1 LAUND MEWS, BELPER, DE56 1FP

13 REV 1 - Scale Drawings / Sections of Replacement Windows

REV	DESCRIPTION	DATE	BY	CHK'D
REV 1	DESCRIPTION - ALTERATIONS TO SPEC AND STYLE / TYPE FOLLOWING CONSERVATION OFFICERS COMMENTS	06.07.23	SG	SG

ELEVATIONS FOR WINDOW REFERENCE 1:100

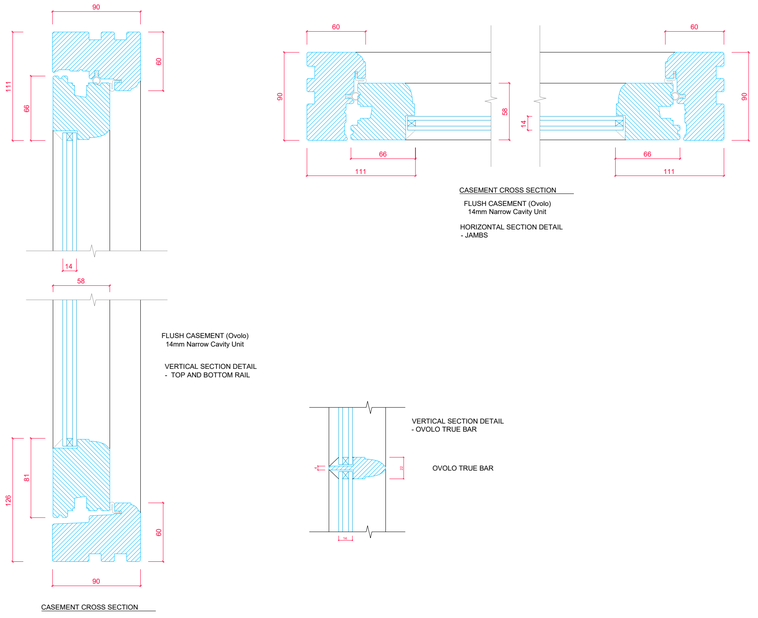
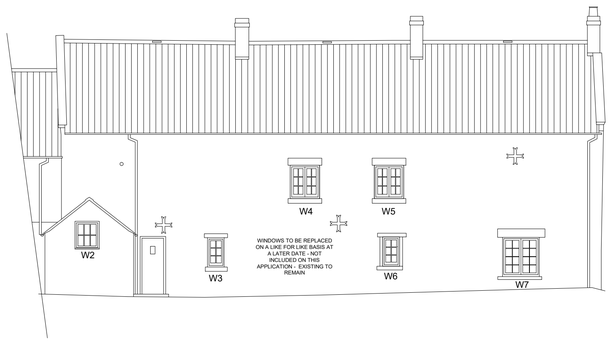
"W1 - we can accept double glazed sealed units, provided that they are flush timber casements and / or fixed timber casements and incoporate a true moulded horizontal glazing bar and have a putty finish to the front.

W2, 3, 4, 5, 6 and 7 – these are unified and relate directly to other windows on the other properties around the courtyard, so I would be opposed to alterations. These can either be retained or replaced like-with-like, with secondary glazing.

W8 and W9 – retain small-paned sashes. The sashes and evidence are very important to the character of the building. It is not feasible to replicate these small panes with double-glazed sashes. I recommend secondary glazing for these two windows. If it is intended to replace the sashes with replacements, we would need to agree details.

W10, 11, 12, 13, 14, 15 – we can accept double glazed sealed units, provided that they are flush timber casements and / or fixed timber casements and incoporate a true moulded single horizontal glazing bar and have a putty finish to the front. By having the outer lights as fixed casements, direct glazed without a sub-frame, it will provide more light. I suggest a central opening timber casement to ground and first floors.

W16, 17 and 18 – we can accept double glazed sealed units, provided that they are flush timber casements, with a central mullion. The option to glaze them with either a single horizontal glazing bar or small panes can be considered but they would need to be true separate panes."

- We have adapted the previously submitted window drawings in line with the below.
- The only variant is W18 - Which is a single window not a double window with a central mullion as requested.
- A cill is only allowed for on W1 which is flush stone work to the gable (all others have Stone Cills)
- All units will be set 50mm into the reveals.
- All double glazed units shown are with slimline double glazing as per section drawing
- All glazing bars are 22mm as per sections
- All front elevation windows to remain as existing. No details provided on any replacements (these will be applied for at a later date if required - the units to the rear elevation and side are the most important due to rotting. The front windows will be okay for a few years).
- All windows to red brick conversion are not included in the application.

Product:
The windows are to be Flush Casement sash supplied by Derwent Windows - Product section drawings are provided.
External putty as per drawings included
